Access Compliance Report Public Rights-of-Way (Curb Ramps)

Main Street: MONTECITO_RD		Cross Street: BRIMHALL_DR		Location:	SW
ADA ID: RPRK211206151026	Ramp Type: Type 4 - Parallel	Initial Pass/Fail: Fail	Overall Compliance: No	Severity Score:	30
Codes/Mitigation Info/Possible Solution			Field Measurements/Component Compliance

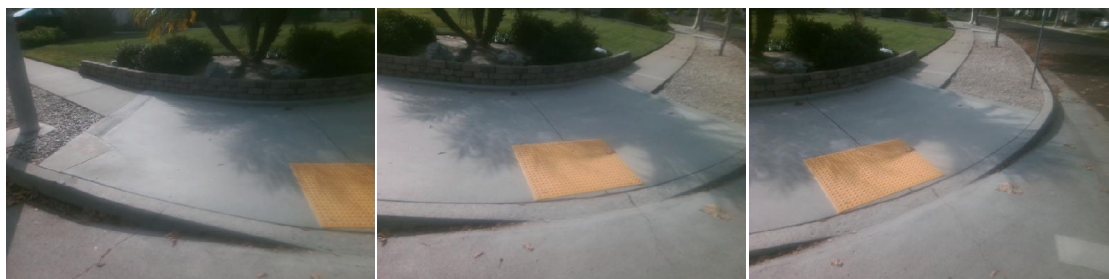
Compliance	Description	Data	Compliance	Description	Data
N/A	Ramp Length LT (in)	113	N/A	Ramp Length RT (in)	108
Yes	Ramp Width LT (in)	112	Yes	Ramp Width RT (in)	112
Yes	Ramp Run Slope LT (%)	6.3	Yes	Ramp Run Slope RT (%)	0.8
Yes	Ramp Cross Slope LT (%)	0	No	Ramp Cross Slope RT (%)	7.1
N/A	Landing Present	N/A	N/A	DWS Provided	N/A
N/A	Landing Length (in)	N/A	N/A	DWS Contrast	N/A
N/A	Landing Width (in)	N/A	N/A	DWS Length (in)	N/A
N/A	Landing Run Slope (%)	N/A	N/A	DWS Full Width	N/A
N/A	Landing Cross Slope (%)	N/A		DWS Offset Type	N/A
N/A	Landing Movement Obstructed?	N/A	N/A	DWS Offset Left (in)	N/A
	Landing Movement Type	N/A	N/A	DWS Offset Right (in)	N/A
N/A	Landing Shared	N/A			
N/A	Clear Space	Yes			
N/A	Clear Space To Crosswalk (in)	N/A			
N/A	Marked Crosswalk 1	No	N/A	Marked Crosswalk 2	No
	Crossing 1 Direction	E		Crossing 2 Direction	N
	Marked Crosswalk 1 Width (in)	N/A		Marked Crosswalk 2 Width (in)	N/A

Remove & Replace Curb Ramp With Two New Directional Ramps or Equivalent.
